TS-324 roof panels had utilized a 4 fastener eave connection until the latest technology update. The old fastener pattern conveniently lined up with the existing hole punching at the end of the panel as shown.

The technology updates (Installation Guide) released April 2021 and (Product Application Guide/ Rev 13) released June 2021 called for an additional eave fastener at a minimum and changed the size to 1/4-14x1 1/4". The fastener spacing no longer had convenient landmarks on the panel for field alignment of the fasteners so the spacing was laid out with the outermost fasteners still aligned with the factory punching and the rest evenly spaced for convenient field layout as shown below. It was brought to our attention by a licensee reviewing the tech update that we had an oversight in the layout due to fasteners falling on the edge of the minor ribs. See the drawing below.

3 INTERMEDIATE RIB PANEL SECTION

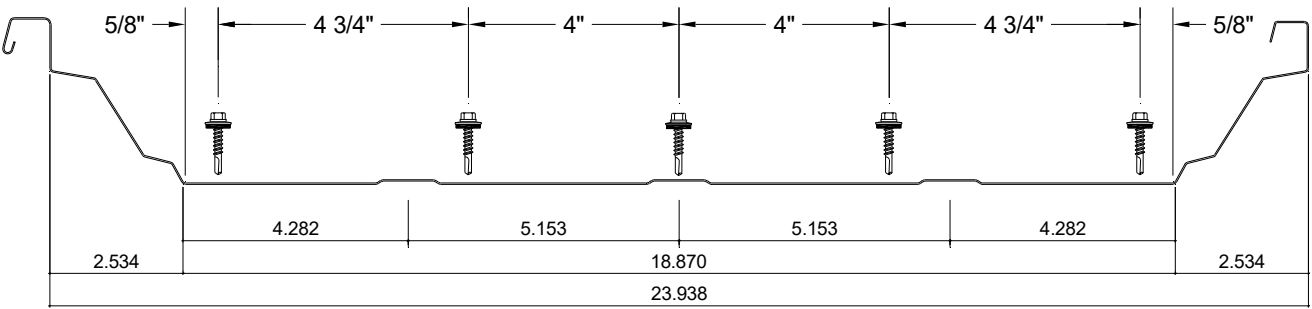
Maintaining the same fastener layout with the minor ribs causes one of the fasteners to land on the center of the middle minor rib which will cause a water trapping dimple and the adjacent flats to fish mouth.

3 INTERMEDIATE RIB PANEL SECTION

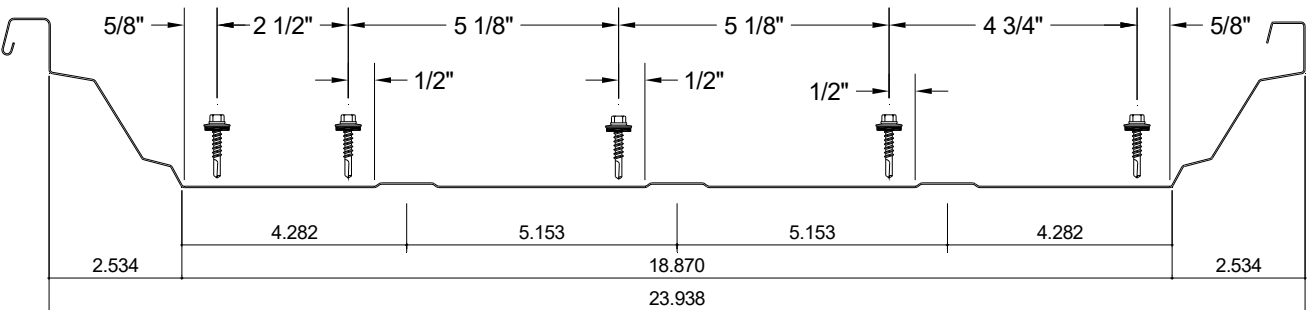
A better solution is to shift the three center fasteners to one side of the minors for a landmark to locate the fasteners during installation. This does leave the installer the chance not to be consistent in the installation process.
